SUBJECT: SEQUOYAH NUCLEAR PLANT, UNITS 1 AND 2 - STAFF ASSESSMENT OF INFORMATION PROVIDED PURSUANT TO TITLE 10 OF THE *CODE OF FEDERAL REGULATIONS* PART 50, SECTION 50.54(f), SEISMIC HAZARD REEVALUATIONS RELATING TO RECOMMENDATION 2.1 OF THE NEAR-TERM TASK FORCE REVIEW OF INSIGHTS FROM THE FUKUSHIMA DAI-ICHI ACCIDENT (TAC NOS. MF3767 AND MF3768)

STAFF ASSESSMENT BY THE OFFICE OF NUCLEAR REACTOR REGULATION

RELATED TO SEISMIC HAZARD AND SCREENING REPORT

SEQUOYAH NUCLEAR PLANT, UNITS. 1 AND 2

Figure 3.3-1 Plot of Staff's and Licensee's Base Case Shear-Wave Velocity Profiles for the Sequoyah site

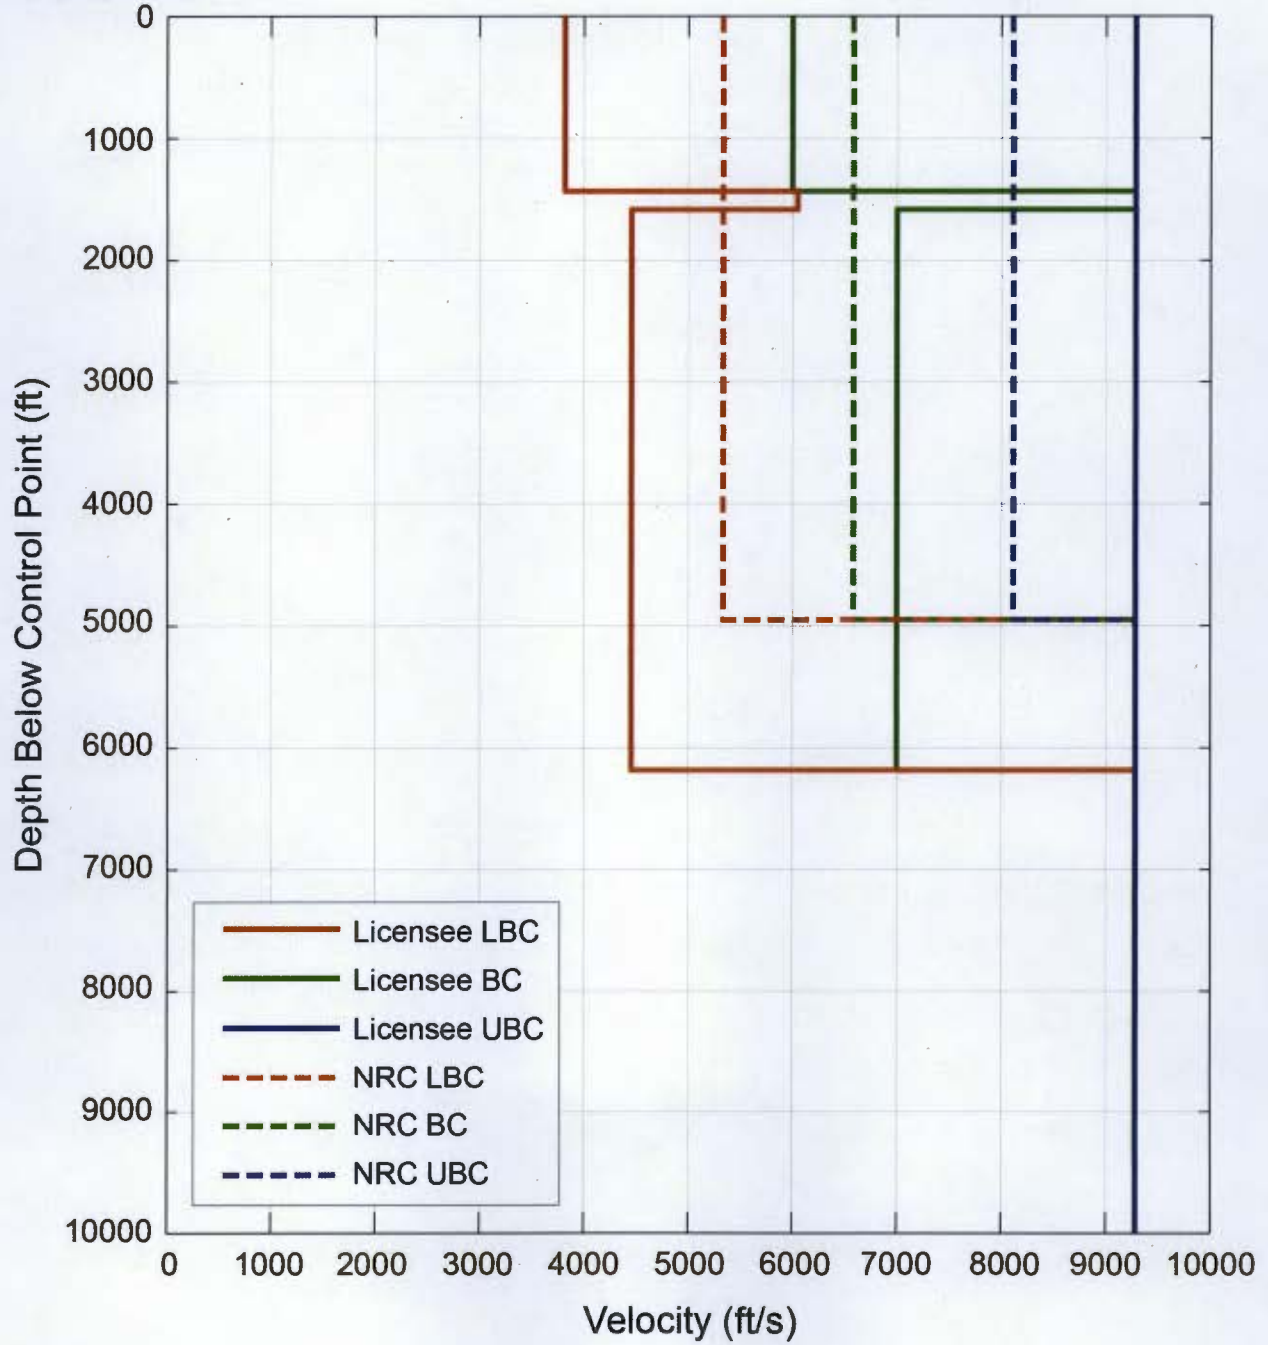
The NRC staff developed three velocity profiles based on the up-hole and cross-hole shear-wave velocity measurements at the site as reported in the FSAR (TVA, Amendment 24, Tables 2.5.1-1 and 2.5.1-2). An investigation of the distribution of these measurements indicate nearly lognormal behavior with a median of 6,567 ft/s [2,002 m/s], and a natural-log standard deviation of 0.164. The NRC staff used these values to develop a set of three velocity profiles from the control point to a depth of 5,000 ft [1,524 m] above reference rock. Figure 3.3-1 of this assessment shows a comparison between the staff's and the licensee's base case profiles. The mean base-case velocity profile of the NRC staff is similar to that of the licensee. For the upper and lower base-case velocity profiles, the licensee used a scale factor of 1.57 (a natural-log standard deviation of 0.35) to reflect its understanding of the uncertainty. In contrast, the staff used a factor of 1.23 (a natural-log standard deviation of 0.164), to obtain the upper and lower base cases profiles, which reflects the staff's interpretation of potential variability in the firm sedimentary rock layers beneath the site.

Figure 3.3- 1 Plot Comparing the Staff's and the License's Median Amplification Functions and Uncertainties for the Sequoyah site

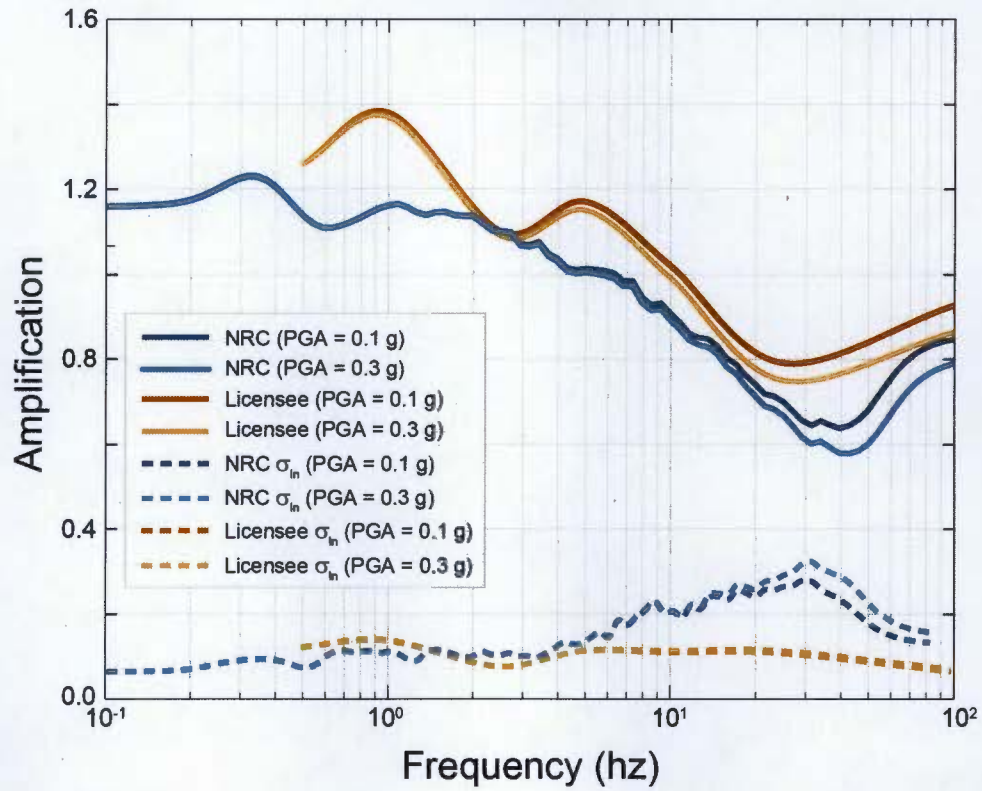
Figure 3.3-2 of this assessment shows a comparison of the staff's and the licensee's median site amplification functions and uncertainties for two of the eleven input loading levels. As shown in this figure, the licensee's amplification functions are somewhat higher than those of the staff's. These small differences in the amplification functions reflect the minor differences in the site response analyses performed by the staff and the licensee. These small differences are within the limits of uncertainty and as such judged by the staff to be reasonable.

Overall, the licensee's approach to modeling the subsurface rock properties and their uncertainty, results in similar site amplification factors with slight differences. As shown in Figure 3.3-3 of this assessment, the control point hazard curves of the licensee and NRC at 1 Hz, 10 Hz, and PGA

Figure 3.4-1 Comparison of the Staff's GMRS, Licensee's GMRS, and the SSE for the Sequoyah site

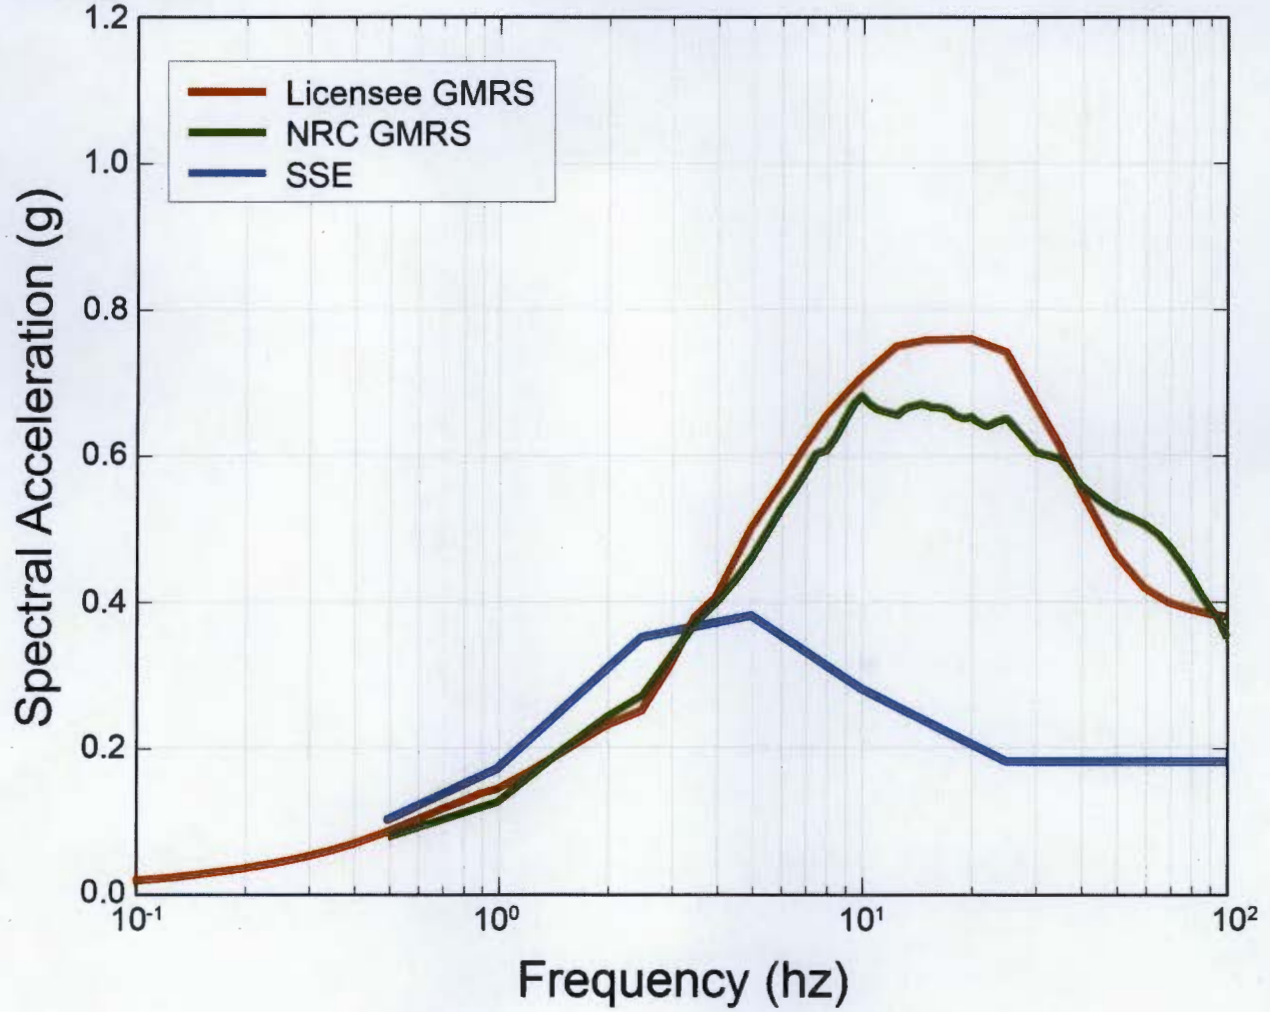
The staff independently calculated the 10^{-4} and 10^{-5} UHRS using the results of its confirmatory PSHA and site response analyses, as described in Sections 3.2 and 3.3 of this assessment, respectively. Figure 3.4-1 of this assessment shows a comparison of the GMRS determined by the licensee to that determined by the staff.

As shown in Figure 3.4-1, the licensee's GMRS shape is generally similar to that calculated by the staff at frequencies less than 10 Hz. However, NRC staff's confirmatory GMRS is somewhat lower than the licensee's in the 10-35 Hz range, and slightly higher above 40 Hz. As described in Section 3.3 of this assessment, the staff concludes that these minor differences over the higher frequency range are primarily due to the differences in the site response analyses performed by the licensee and staff. The staff concludes that these differences are acceptable because the licensee followed the guidance provided in the SPID with respect to both the PSHA and site response analysis for the Sequoyah site.
